June 13th, 2025

RE: *Meliadine Mine Jetty A8 Design Report and Drawings for 2AM-MEL1631 water licence*

250603 2AM-MEL1631 REP-Design Report and Drawings for Jetty A8 CIRNAC
Comments-IMLE

Specification pump sheet 6542-S-265-020-EDS-001

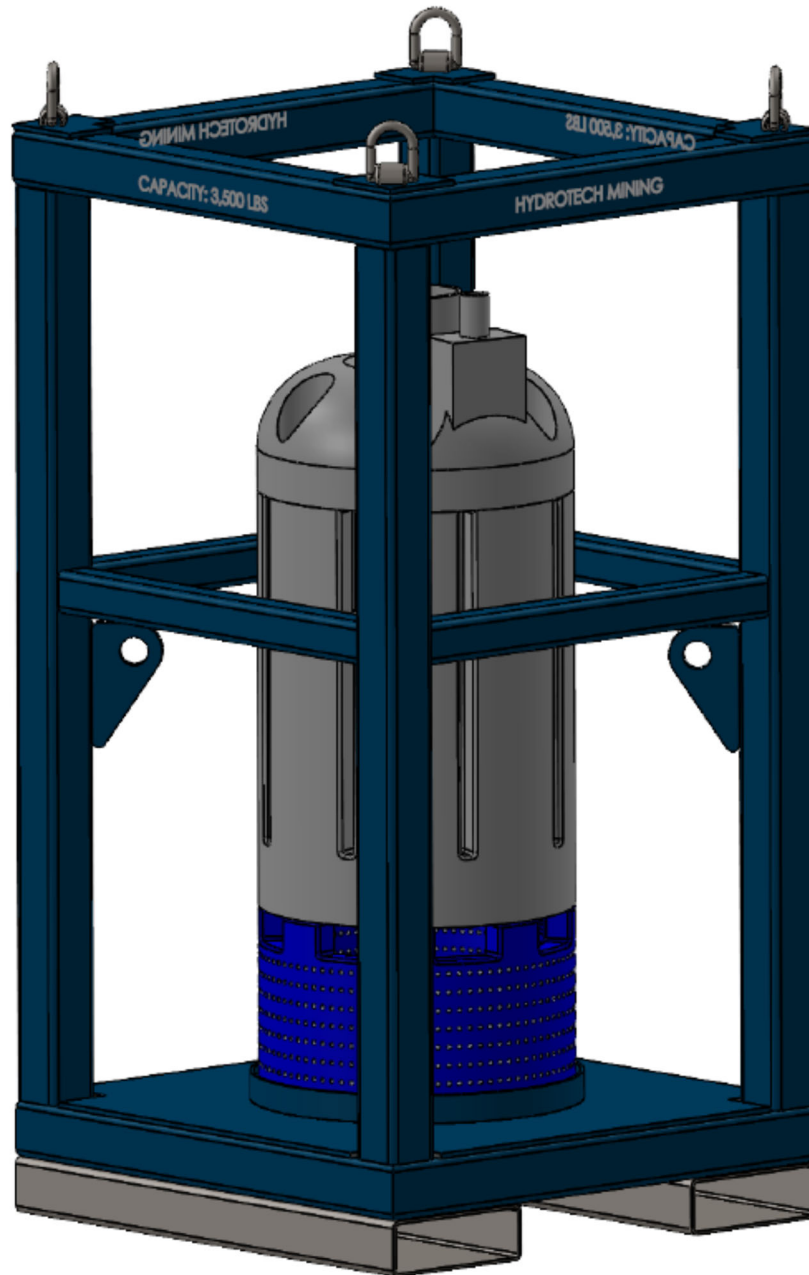
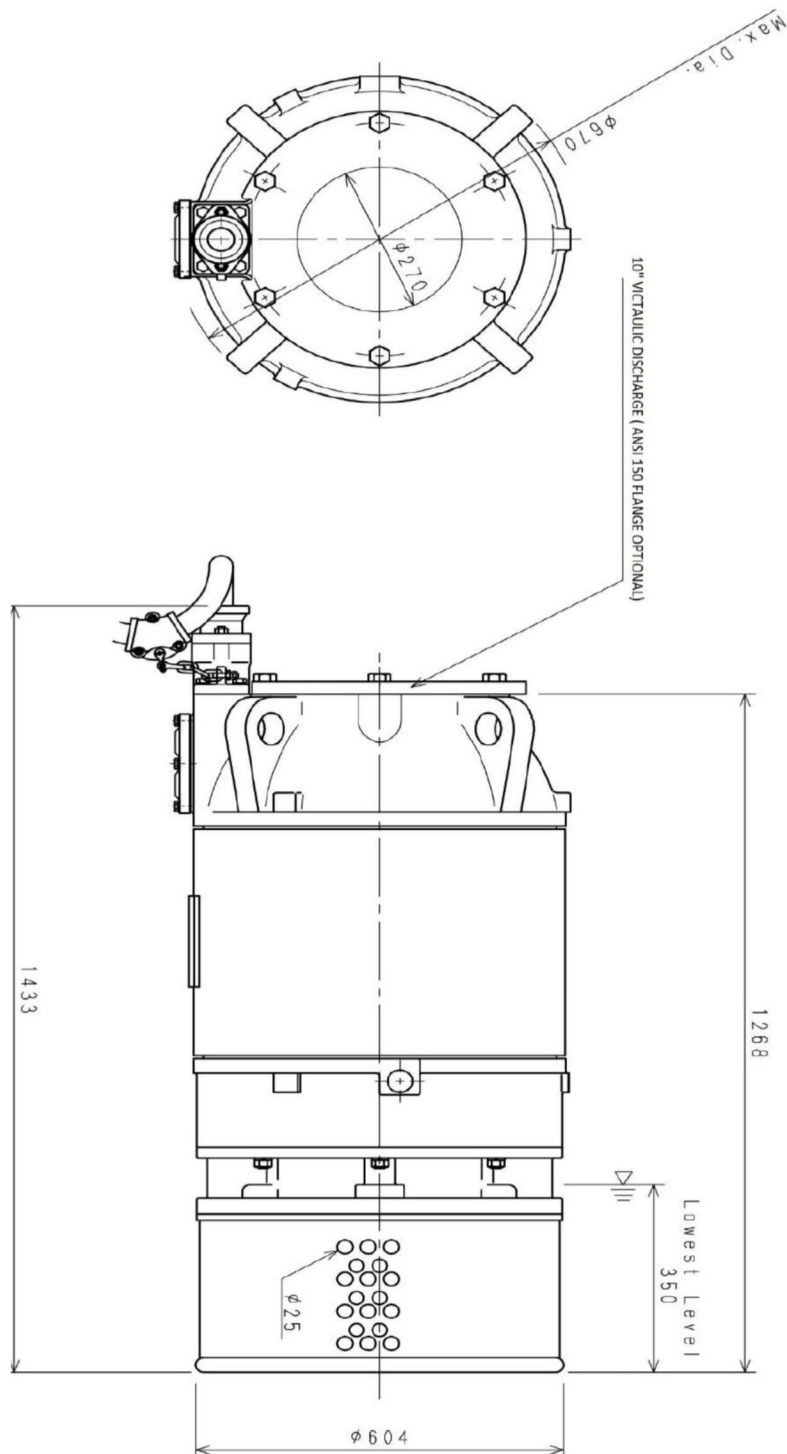
CIRNAC-3: SUBMERSIBLE PUMP SPECIFICATIONS AND STORAGE LOCATION

The specifications for the submersible pump and the storage location when not in use were not provided. CIRNAC is concerned that without information about the type of fuel used and its storage location it is difficult to ensure safe handling of fuel within the management plan.

(R-03) CIRNAC recommends that the applicant state the specifications for the submersible pump and where it will be stored when not in use.

The submersible pump that will be used at CP9 as design is a MAV-1075HC, 75HP. The specification sheet is provided in Appendix 2. At the end of the pumping season, the pump will be winterized in the water management shop and stored in a non-heated seacan.

2025 Dewatering Access Roads

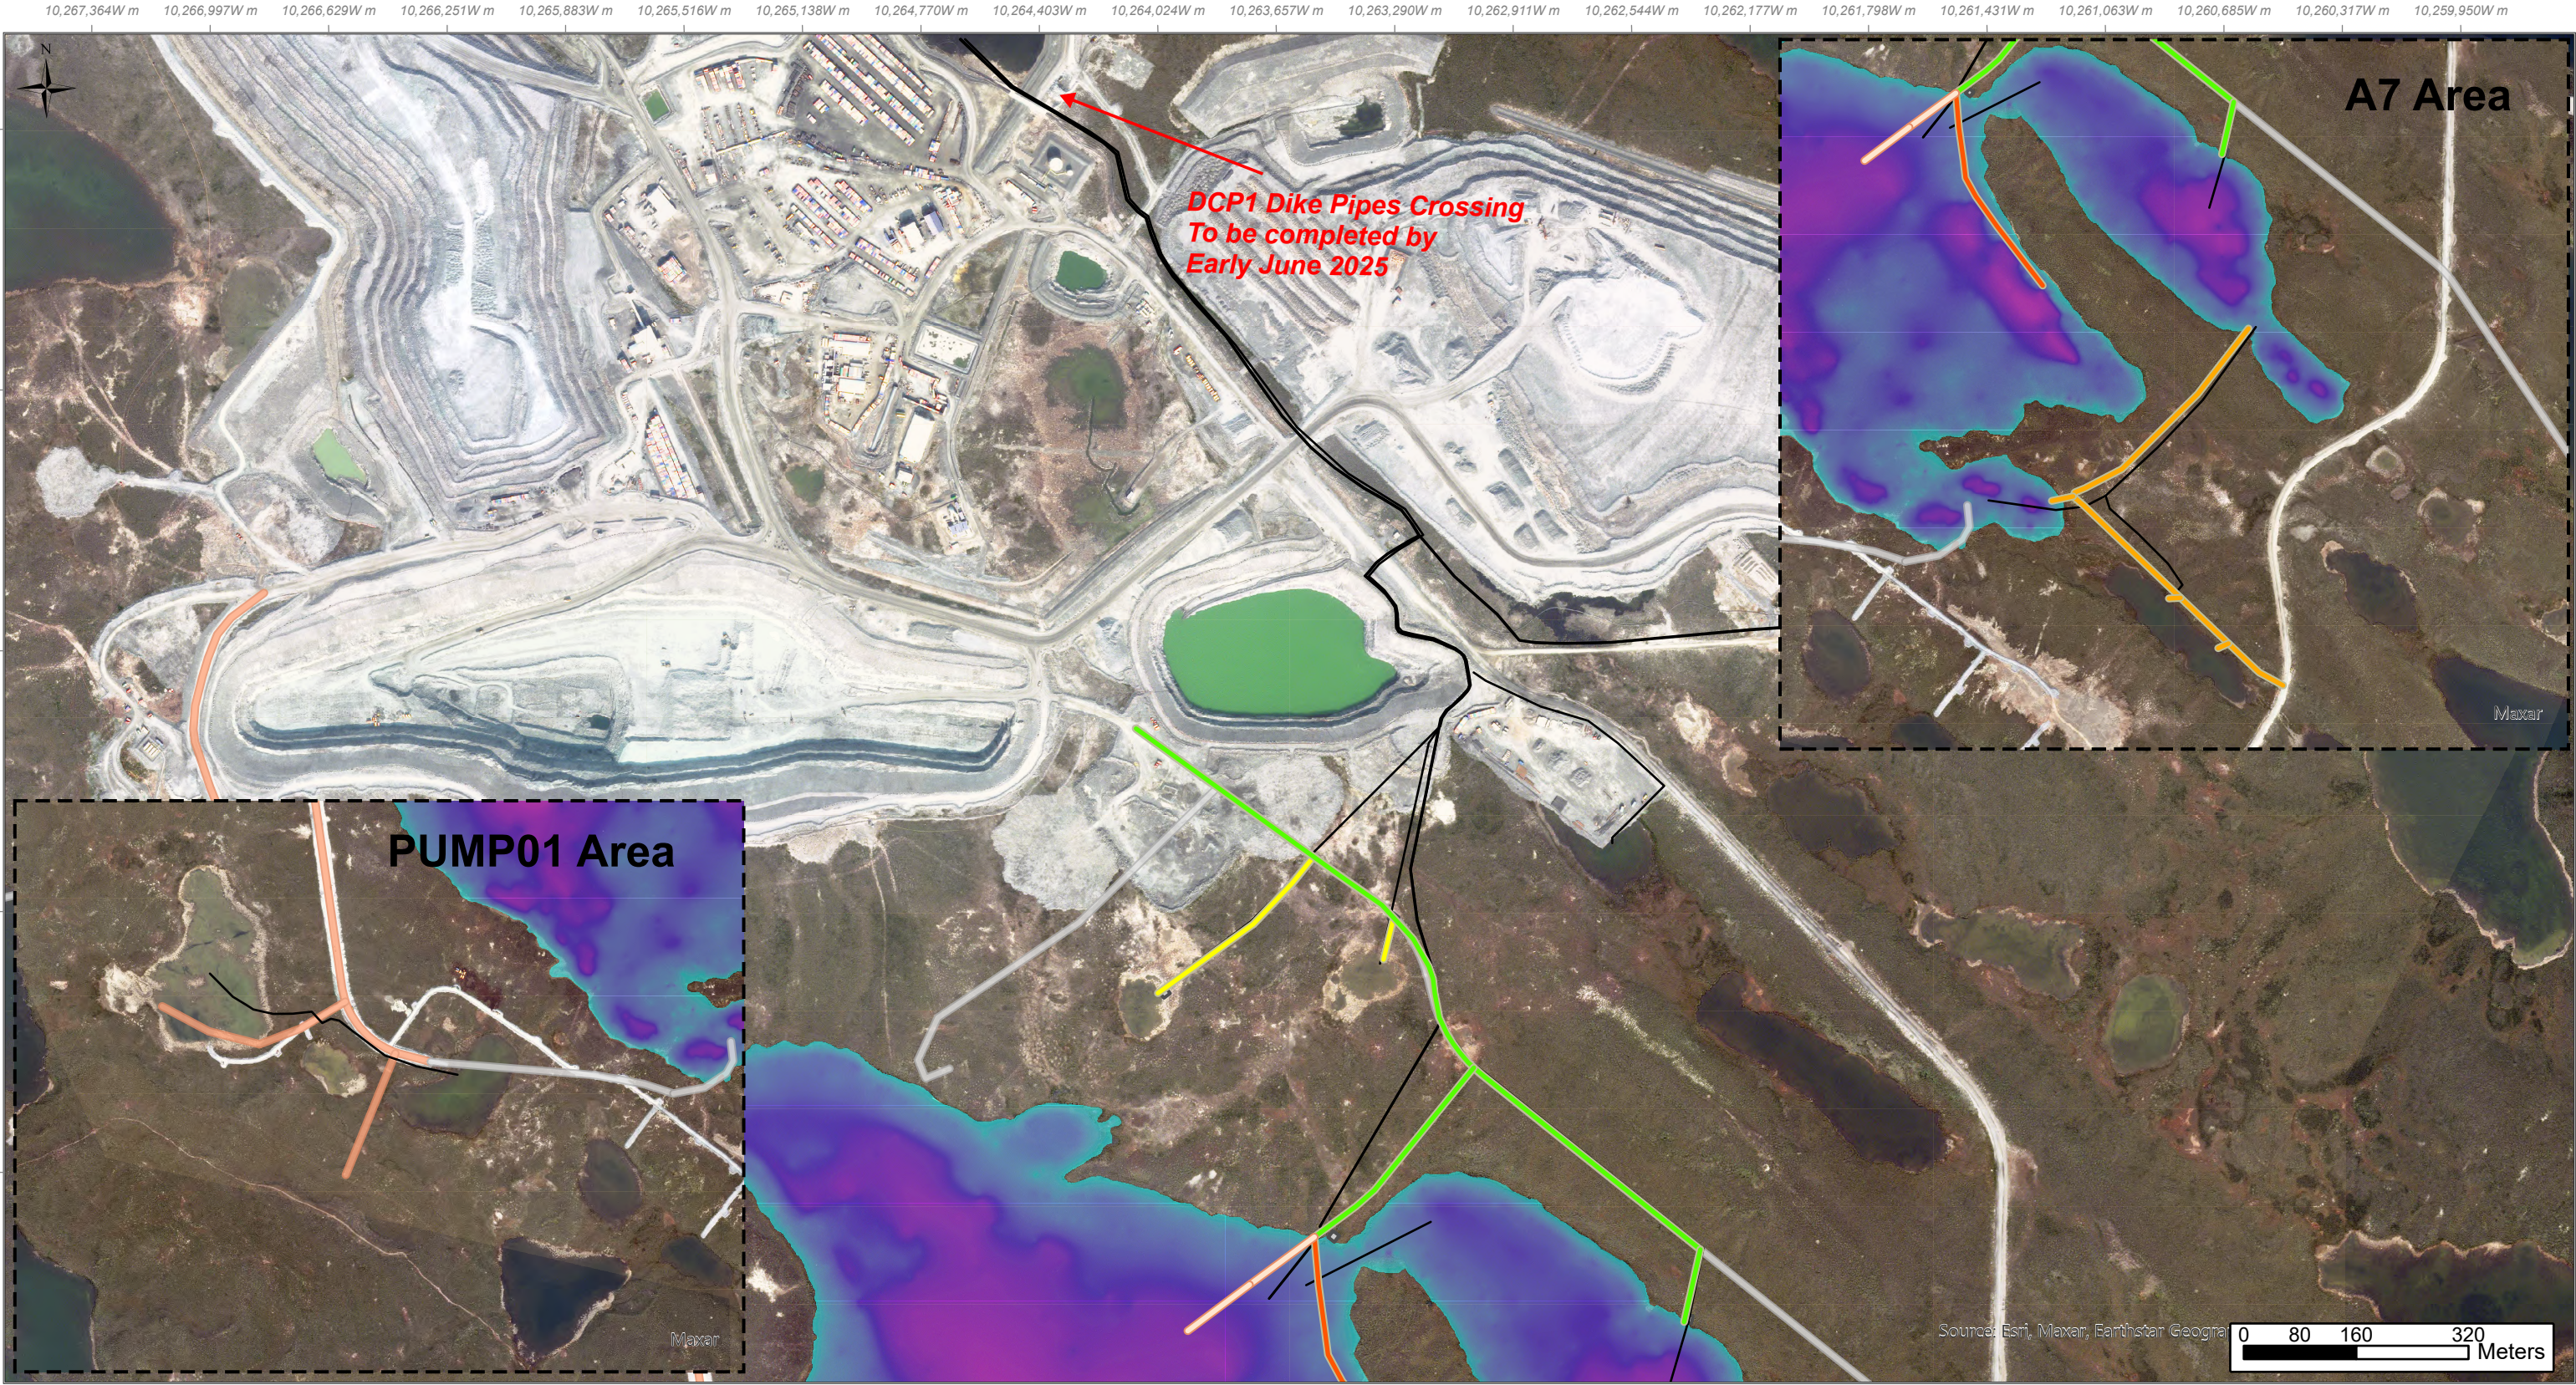
The drawings indicate that there will be a road located on the far side of the lake from jetty A8 and it is labelled as the Road to Pump yet there is no indication if this is the access road that will also be used for the construction of the jetty. CIRNAC is concerned by the lack of clarity around the use of the access road to the jetty for construction purposes and the lack of details around water management for the road.

(R-04) CIRNAC recommends that the applicant clarify if the road to the pump is the access road to be used for the construction of the jetty and provide any water management plans that may need to be implemented as a result.

Small access roads have been built to access the area where the A8 jetty will be built. These access roads have been inspected by CIRNAC provided in Appendix 1. To limit the disturbance

of the tundra these access roads are following the exact same path as the final haul roads that are planned to be built in winter 2026 in the area. The paths of the access roads and planned haul road are shown on the 2025 Dewatering Access Roads Layout provided in Appendix 3.
